YEAR
1992

MODEL
INTEGRA
LEGEND

BULLETIN NO.
92-004

Product Update: Oil Pressure Switch

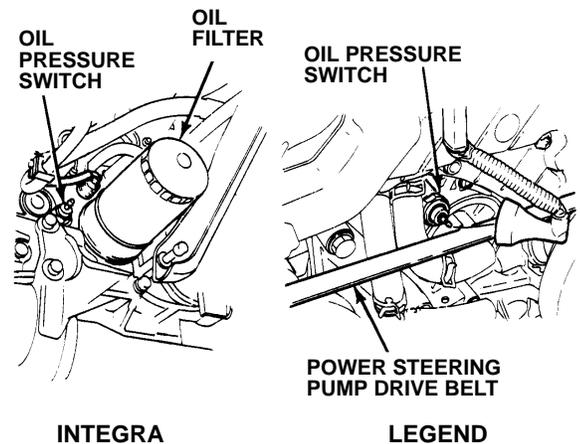
Inspect the oil pressure switch to determine if it has a green plastic end or black plastic end. If it is green plastic, replace it with the switch listed under PARTS INFORMATION.

2. Locate the oil pressure switch. To inspect the plastic end to see what color it is, remove the wire and boot by pulling them straight off.

3. a) If the switch has a black plastic end, reconnect the wire and boot and go to step 4.
b) If the switch has a green plastic end, replace it with a new unit. Coat the threads with a 3 mm wide bead of Liquid Gasket (P/N 087180001) before installation. Torque the switch to 1.8 kgm (13 lbft).
4. Lower the hoist (Integra only). Check the engine oil level and add as needed.
5. Center punch a completion mark over the last digit in the VIN on the engine bulkhead.

Oil pressure switch: P/N 37240-PT0-013
